*LIGO Laboratory / LIGO Scientific Collaboration*

E1100867-v17

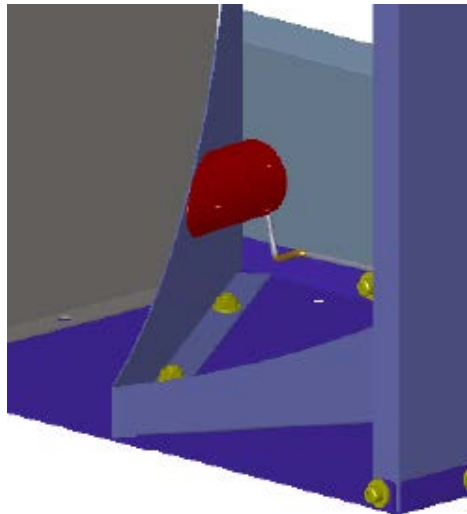
7. Lay Assembly down
8. Attach “SLC Arm Cavity Baffle Center Skin” D1000976 and “Arm Cavity Baffle Center, Mirror Skin” D1101796 to “SLC Arm Cavity Baffle Bottom Skin” D1000975 and “Brace, Lifting, Arm Cavity Baffle” D1101427. Refer to D1200657 or D1200314 assembly drawing Detail B on Sheet 2 for clarification.
  - a. Install hardware 6 places
  - b. Round Holes (screw, SSTL, Brace, washer, nut)
    - i. FA-2412-NA, Flat Head Screw #10-24 X 3/4”L, SSTL - oxidized, Qty 6
    - ii. 98019A330, Flat #10 Washer, SSTL, Qty 6
    - iii. N-1024-A, Hex Nut #10-24, SSTL - Silver Plated, Qty 6
